ADDENDUM #2

Date: July 12, 2016

Project: City of Greensboro Police Department
Partial 3rd and 5th Floor Upfits
320 Federal Place, Greensboro, NC 27401
RE-BID (Contract Document)

SHEET TITLE
 3RD FLOOR HVAC PLAN
 (NORTH)
 SHEET No.
M2.1

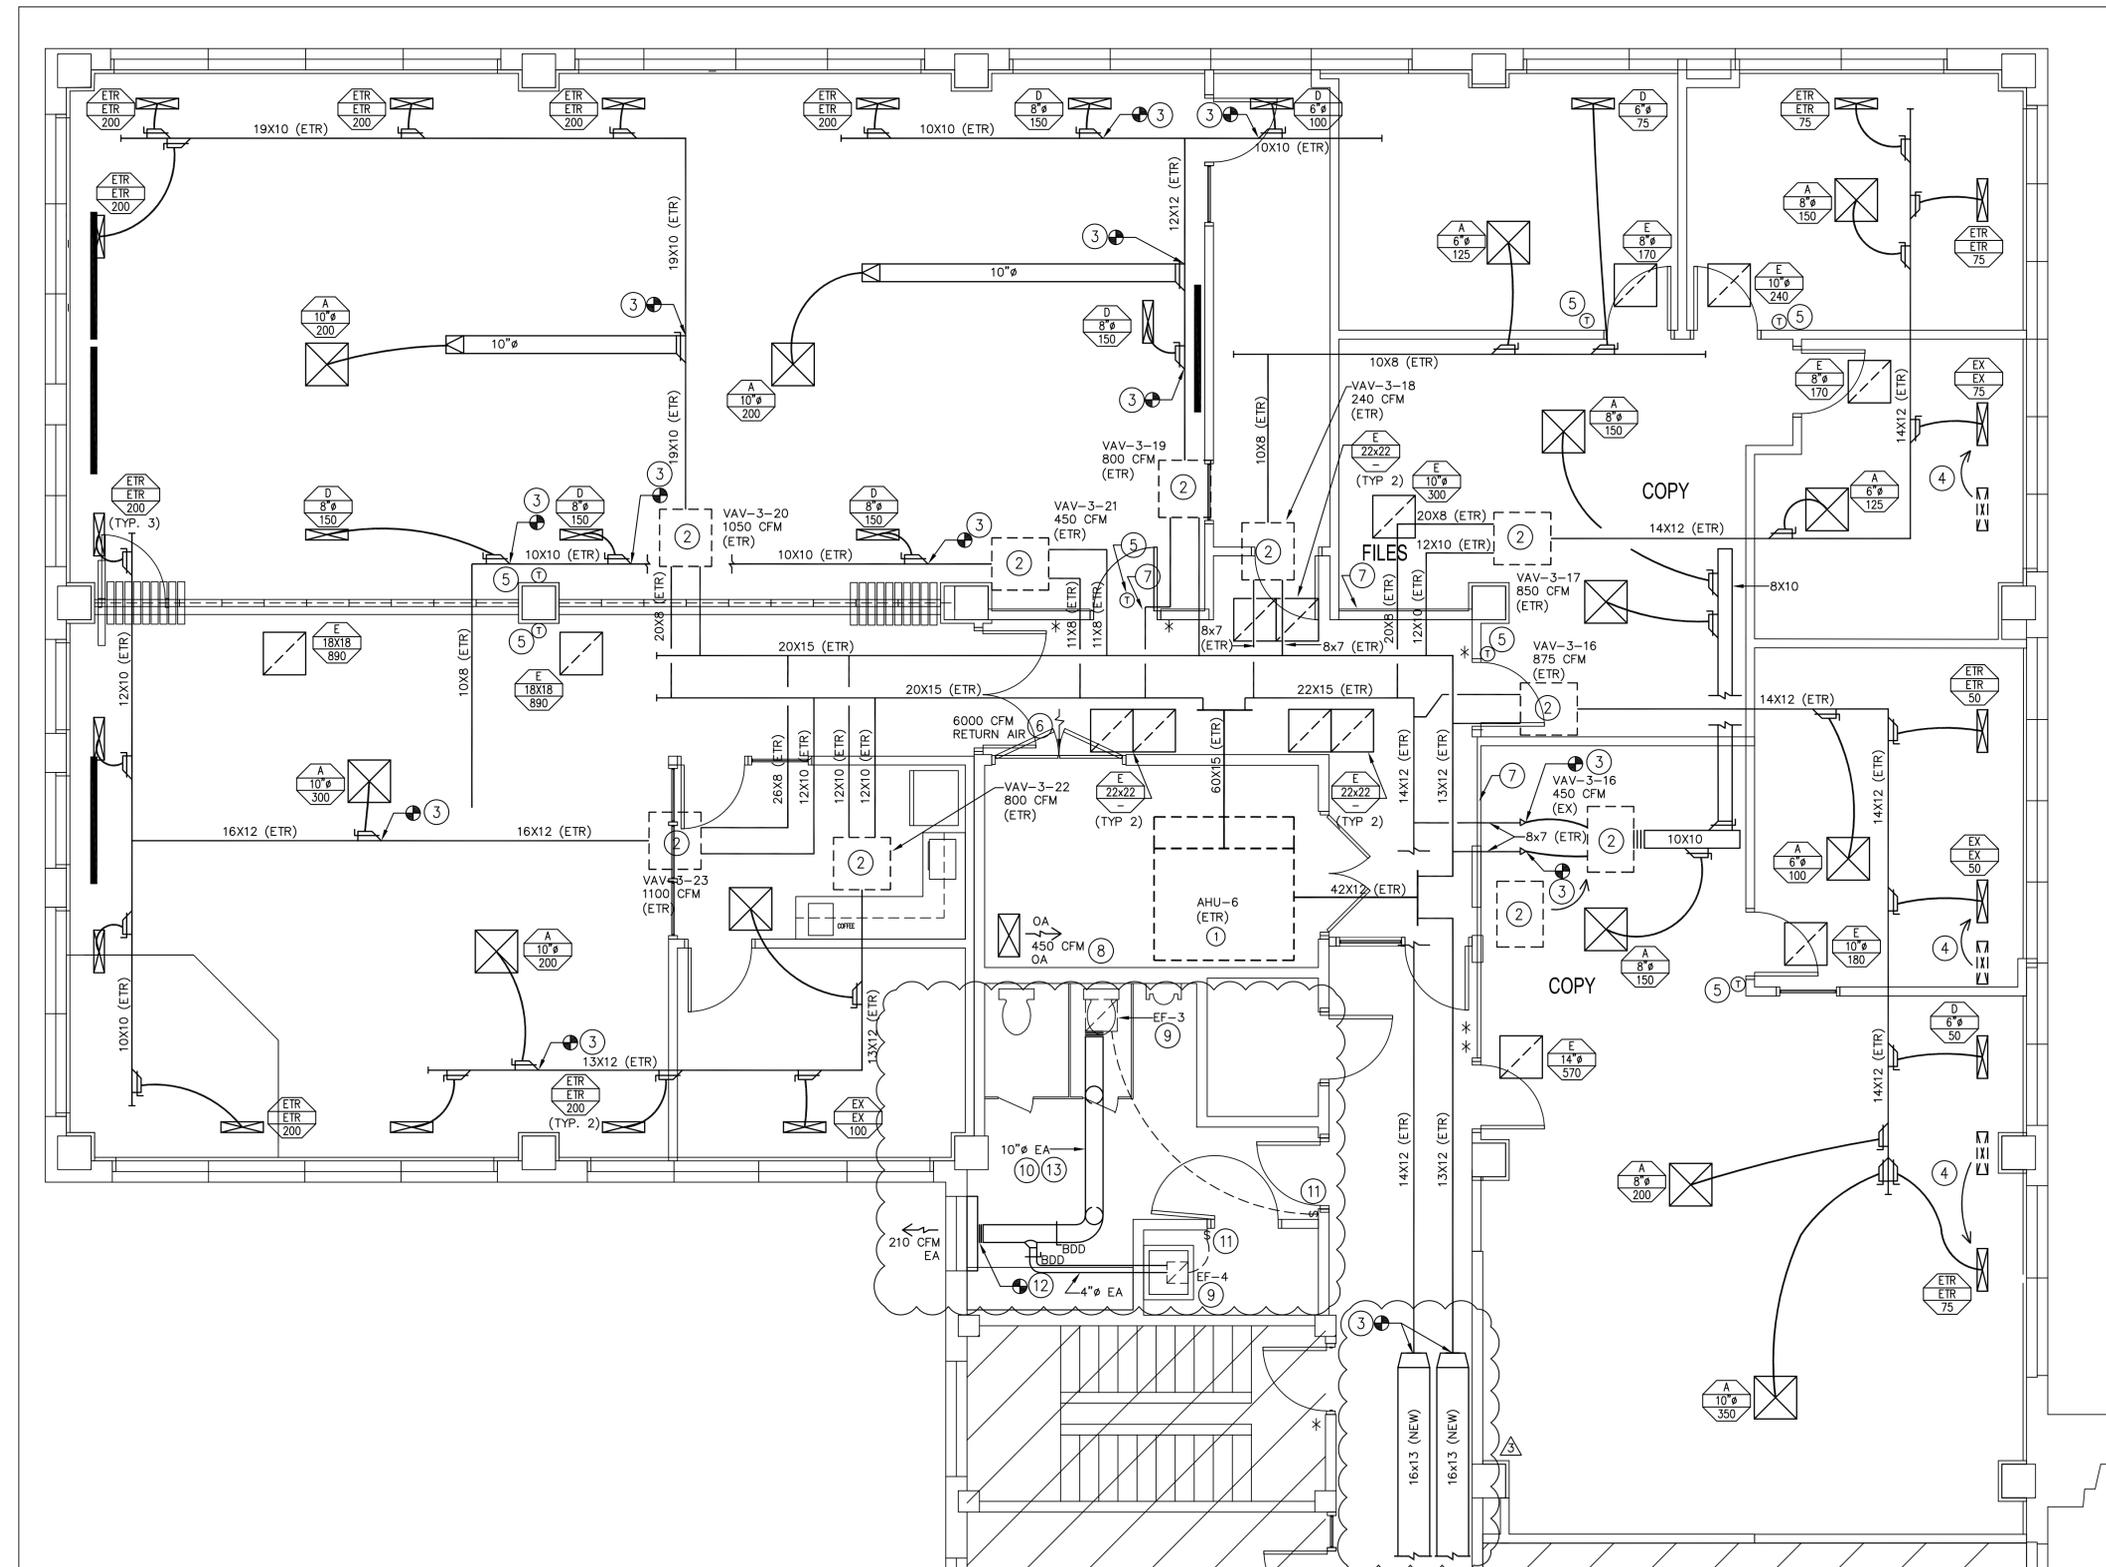
2. Refer to revised Mechanical drawings M201, M202 and M301. Revisions made to the existing Server Room.
3. Refer to revised Electrical drawings E3.2 and E3.3. Revisions made to Server Room and Restrooms' exhaust fans.
